Bill No. 16R-185

FACTSHEET

TITLE: **SPECIAL PERMIT NO. 16025,** request of Neighborhoods Inc., dba NeighborWorks Lincoln, to allow for the development of a new Community Unit Plan, on property generally located at 828 D Street and 848 D Street.

LINCOLN CITY/LANCASTER COUNTY PLANNING STAFF REPORT

G1.1

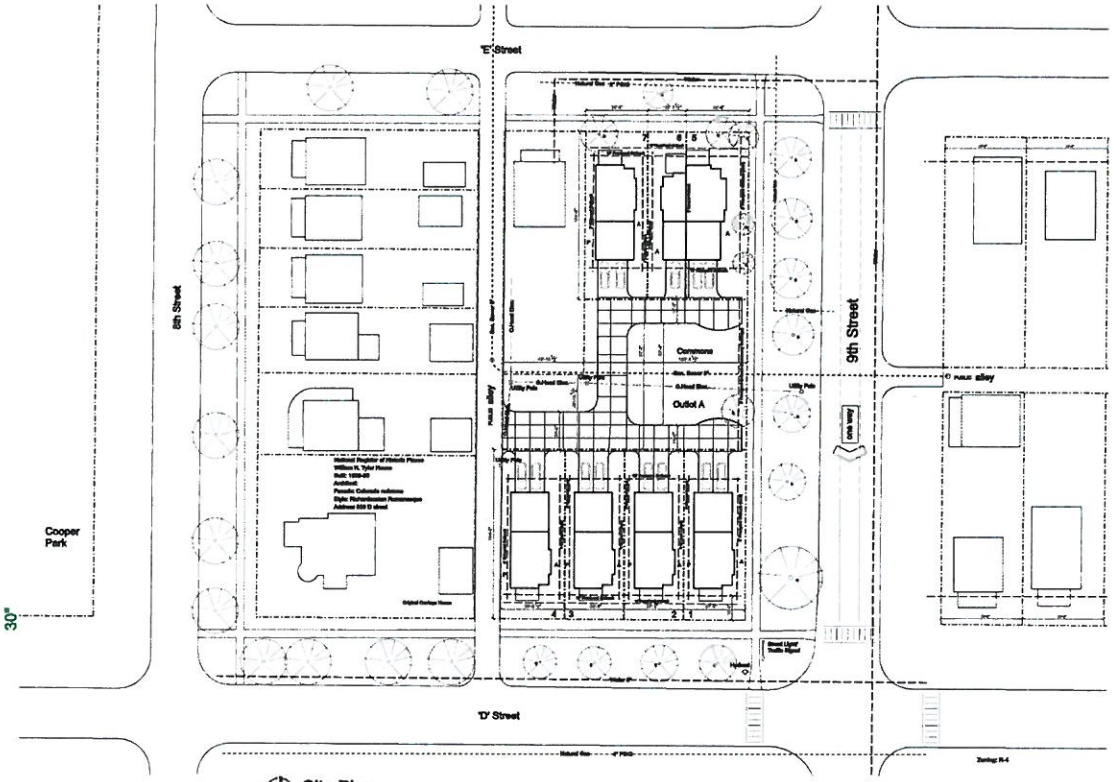
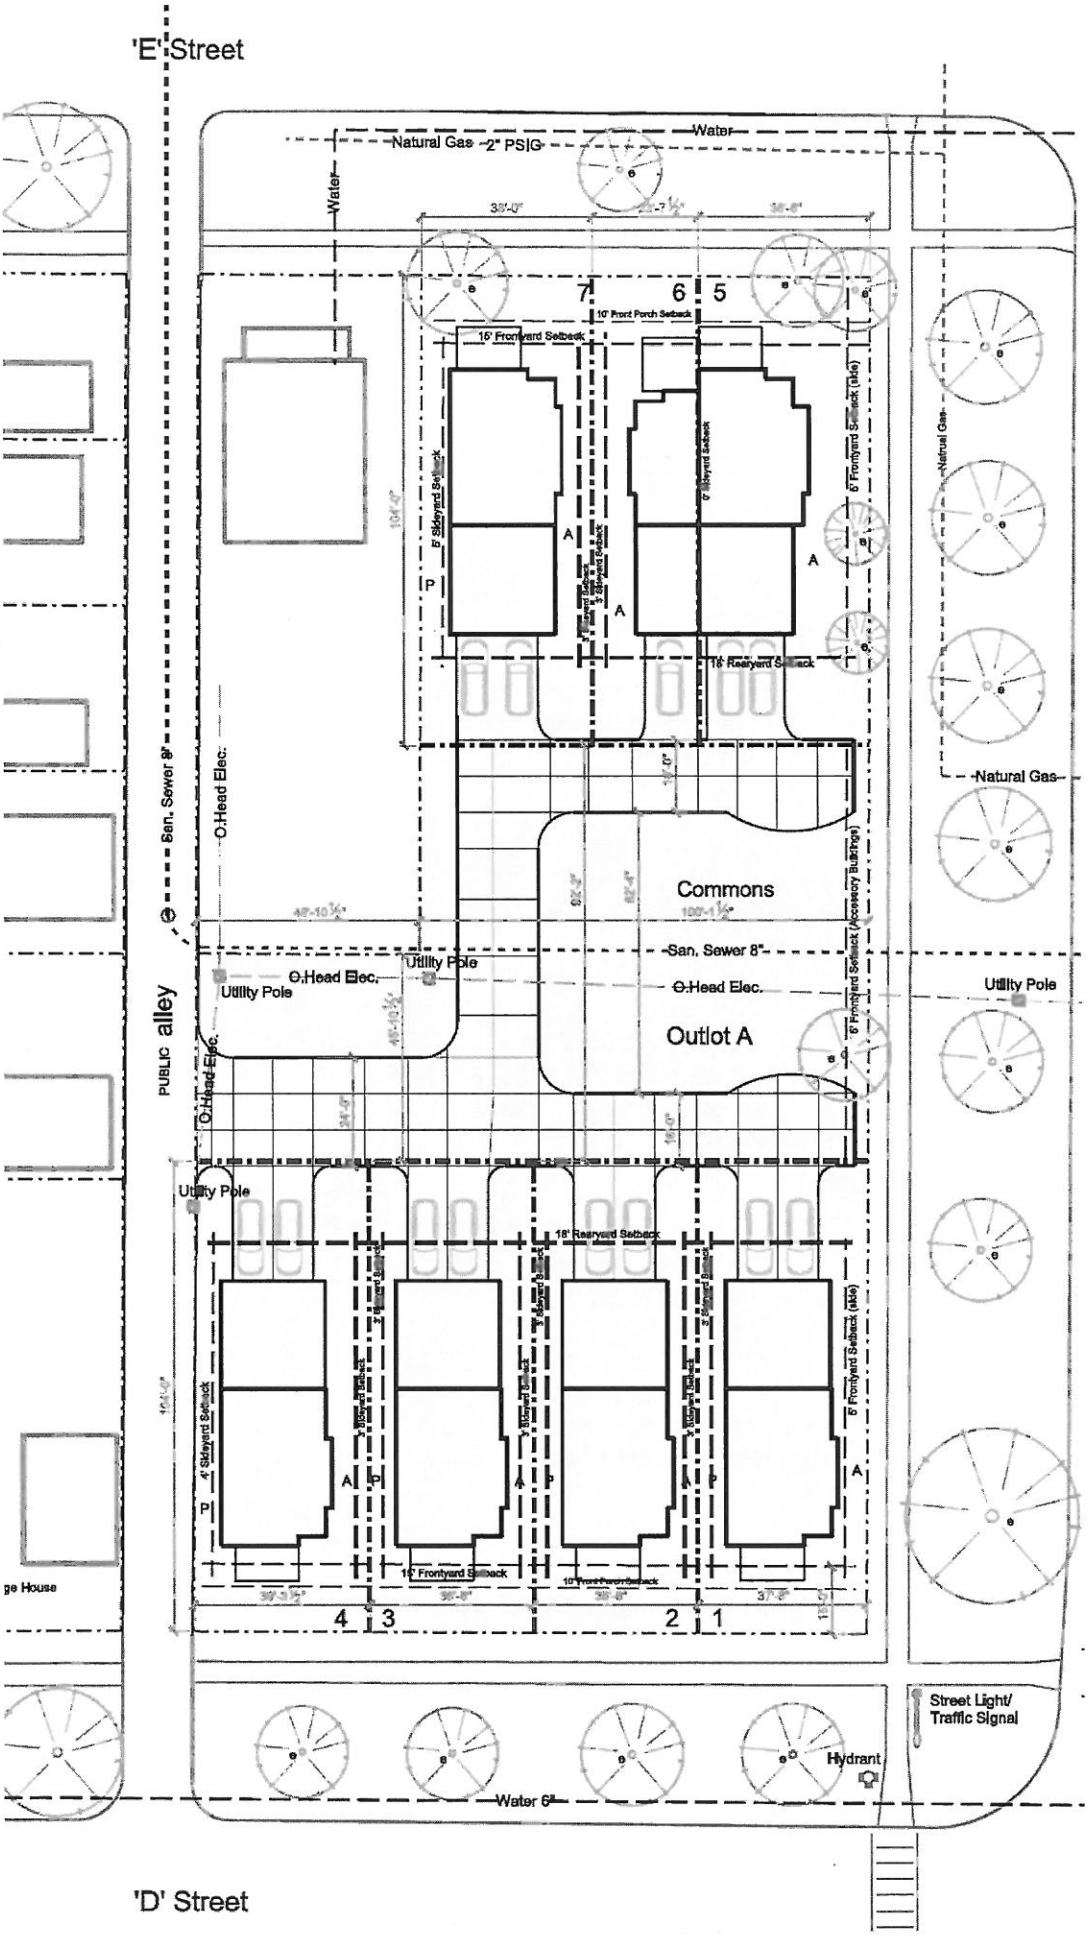
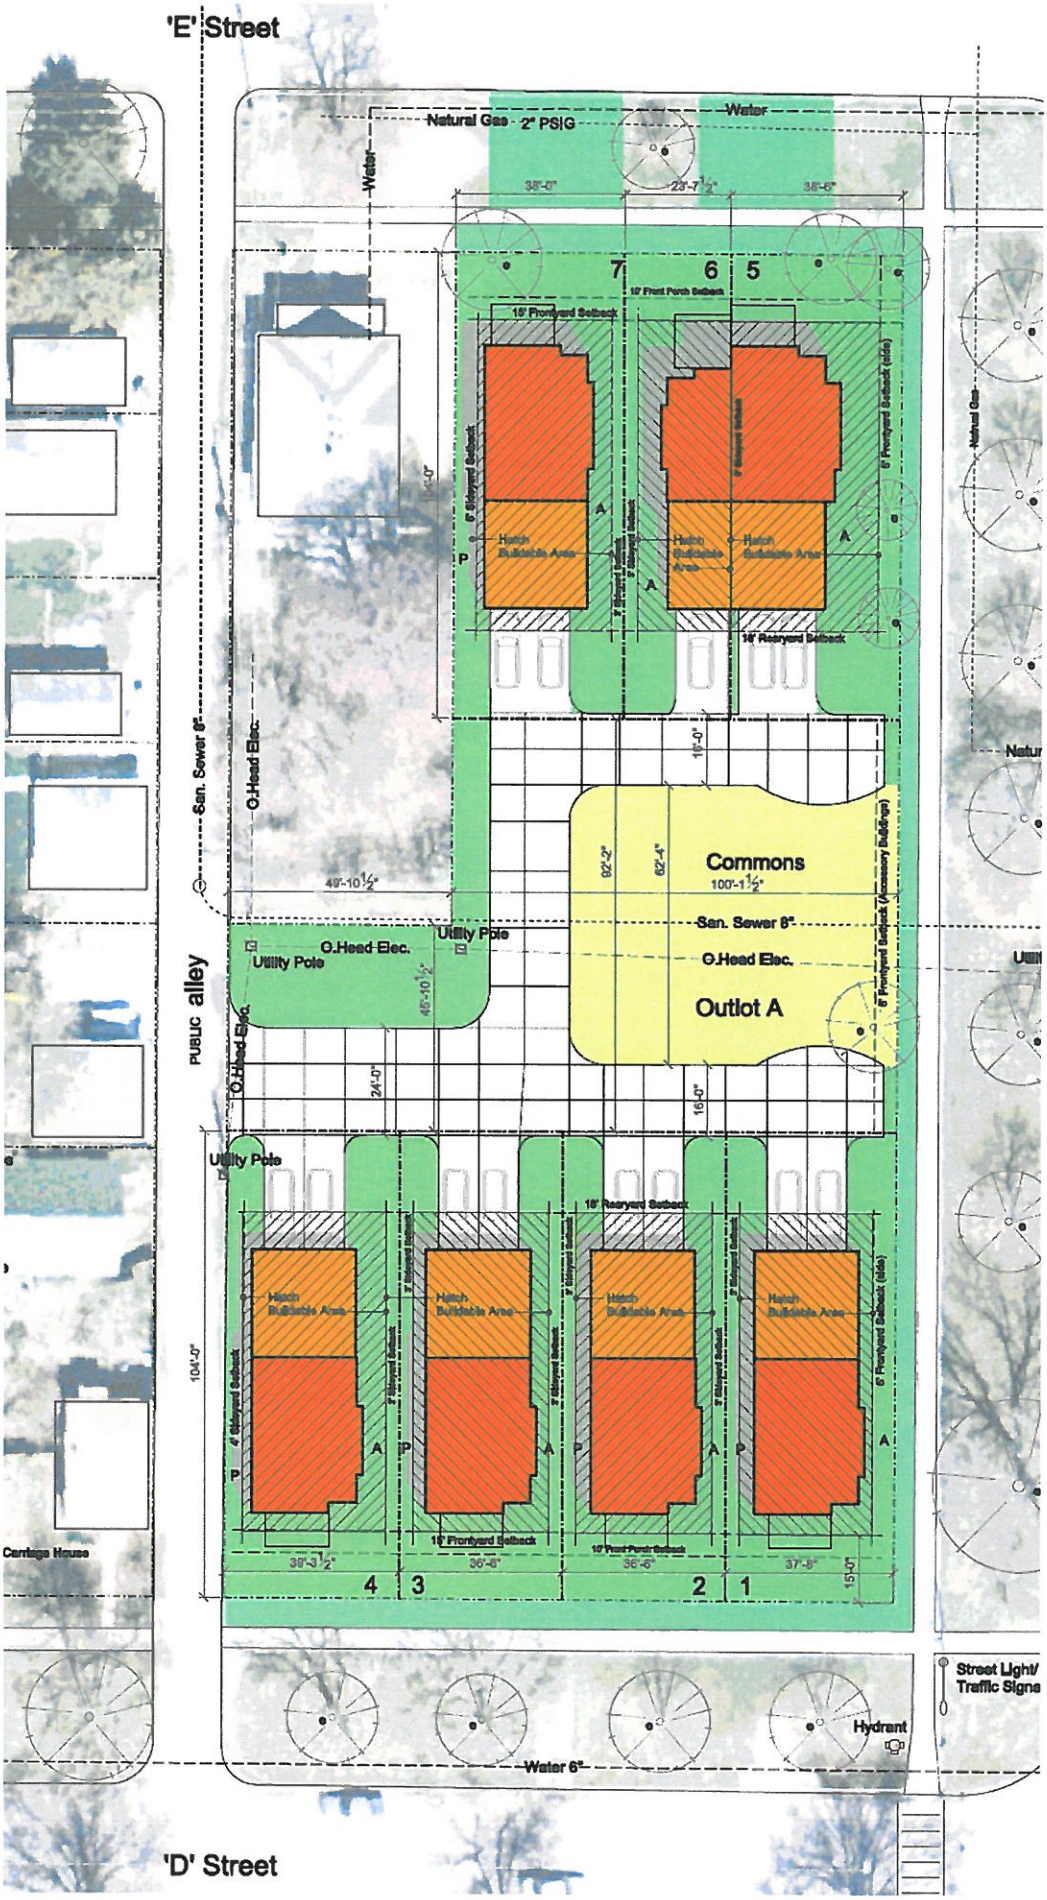
1.1 Revise the sheet numbering to show “Sheet 1 of 1" for Sheet G1.1 as this will be the only sheet for the approved CUP.

1.2 Revise the sheet title to read, “Cooper Commons Community Unit Plan, Special Permit #16025" and delete the “Submittal Documents” subtitle.

1.3 Under the Proposed CUP table, correct “Font” to “Front”.

1.4 Remove the “Drawing Index”.

1.5 Remove “(side)” from the front yard setback label along 9th Street.

1.6 Revise Note A.3 to state “Building footprints are conceptual and may be located anywhere within the approved building envelopes.”

1.7 Revise Note B.2 to state “Accessory Buildings are permitted in the identified Commons area in Outlot A and must meet the minimum 5 foot front yard setback to 9th Street.”

1.8 Revise Note C.1 to state “A final plat will be required according to the proposed lot sizes.”

1.9 Revise Note C.2 to state “Proposed exterior home designs are subject to review and recommendation by the Historic Preservation Commission and must meet the Design Standards for Neighborhoods.”

1.10 Remove the “Lot Total - 8" under the Proposed Lots table.

1.11 Under the Proposed CUP table, change the proposed “3,714 average square feet” to “3,500 single family/ 2,400 two-family lots” to allow for minor variation.
